**Site Formation and Infrastructure Works  
for Public Housing Development near Tan Kwai Tsuen,  
Yuen Long – Investigation, Design and Construction**

**FINAL WATERWORKS  
IMPACT ASSESSMENT  
REPORT FOR S16 PLANNING  
APPLICATION  
(INTENSIFICATION SCHEME)**

**Responses to Comments on  
Final Water Impact Assessment Report for S16 Planning Application  
(Intensification Scheme) (Issue 1)**

Drawing No.	Scale
199086/BIN/WIA/502	1 : 200 (A1) 1 : 400 (A3)

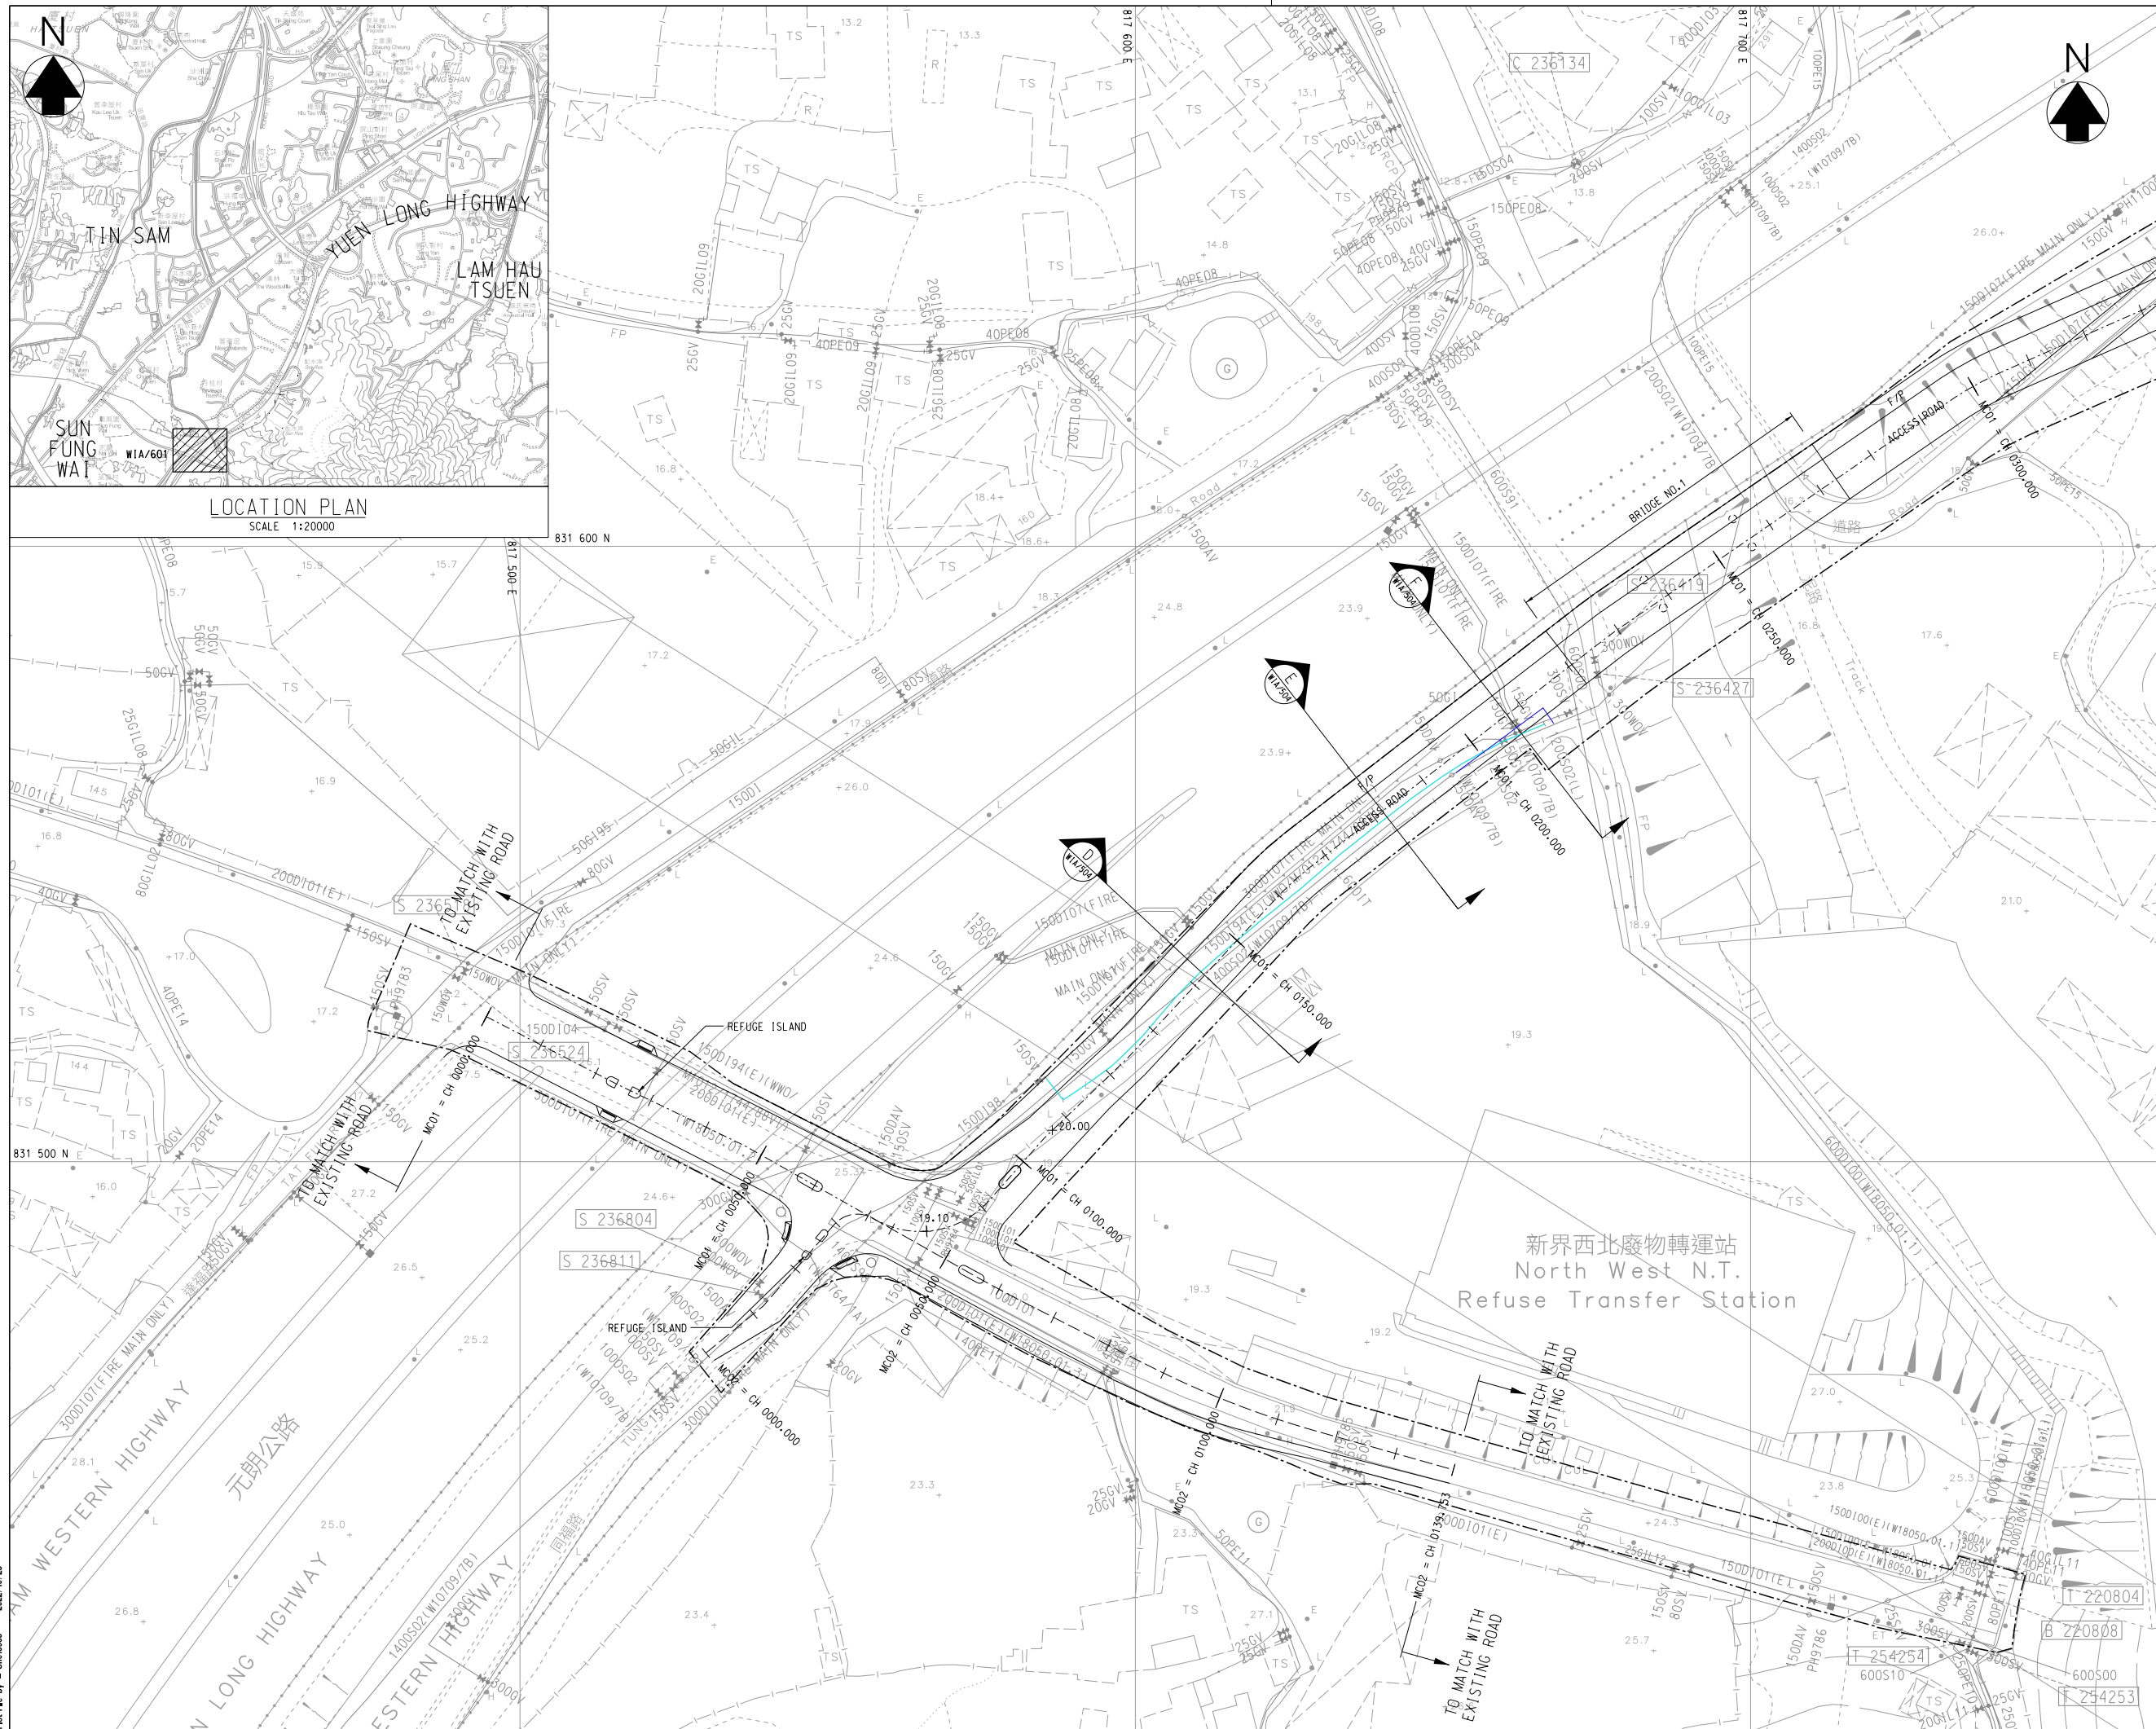
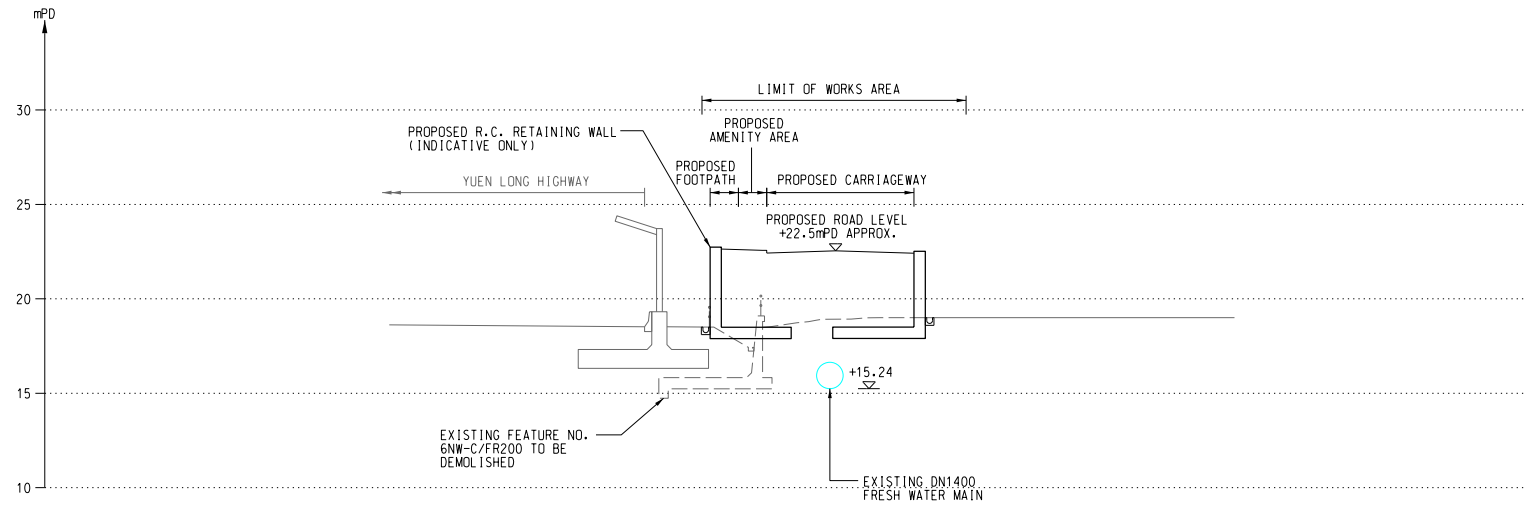
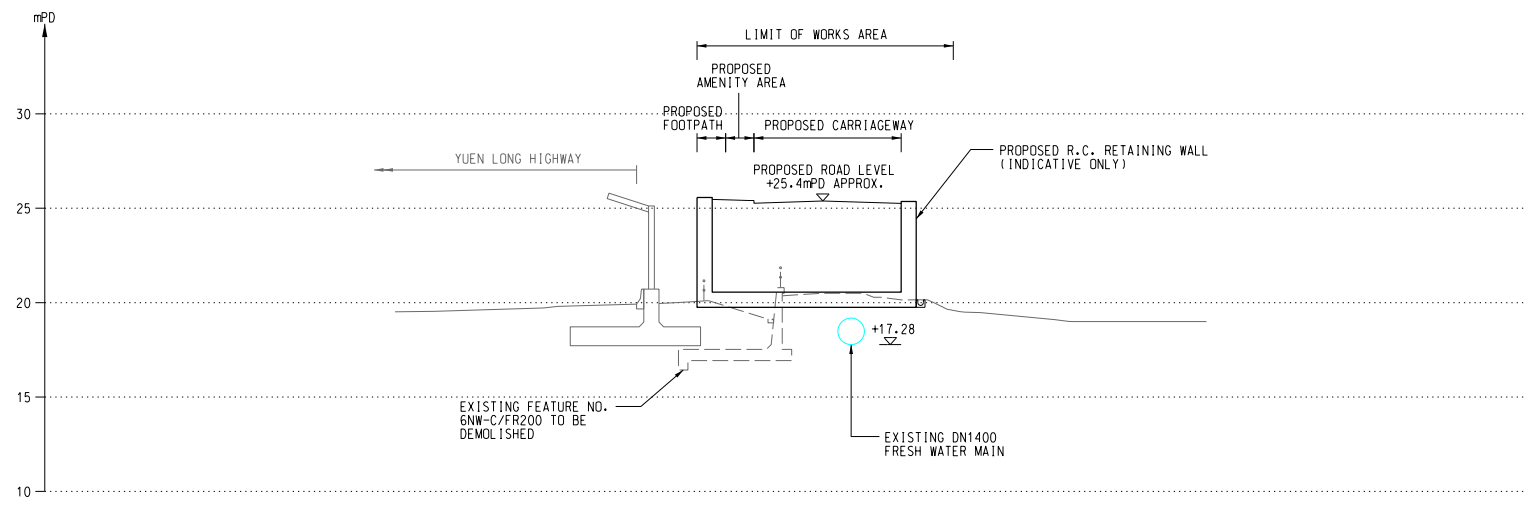
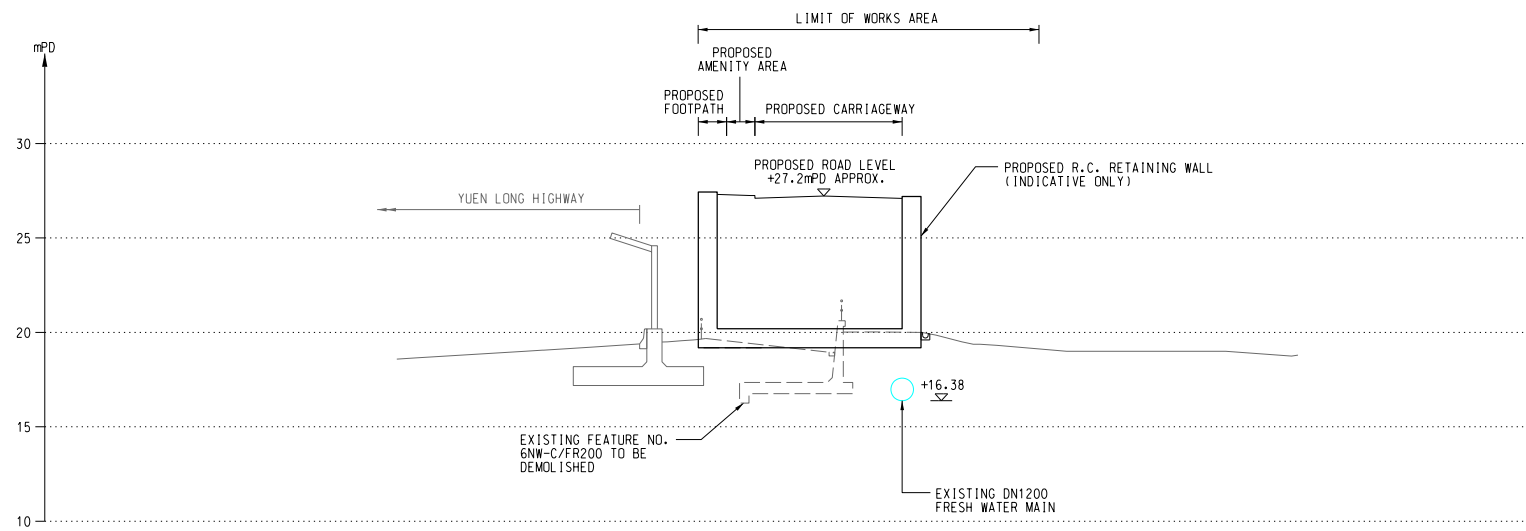
Drawings 199086/BIN/WIA/502 & 602	
<p>4. Drawings show that the existing DN1400 trunk main and DN1800 distribution main will be affected and diverted. Your proposal will critically affect the water supply to Tin Shui Wai and Lau Fau Shan area., large scale water suspension could be resulted. Please review your design to avoid direct conflict and proposed suitable protection measures feasible for maintenance.</p>	<p>Due to site constraints, it is necessary to divert the existing DN1400 trunk main and DN1800 distribution main. As the diversion area is far from the housing site, a detailed diversion scheme for the affected mains will be submitted separately.</p>
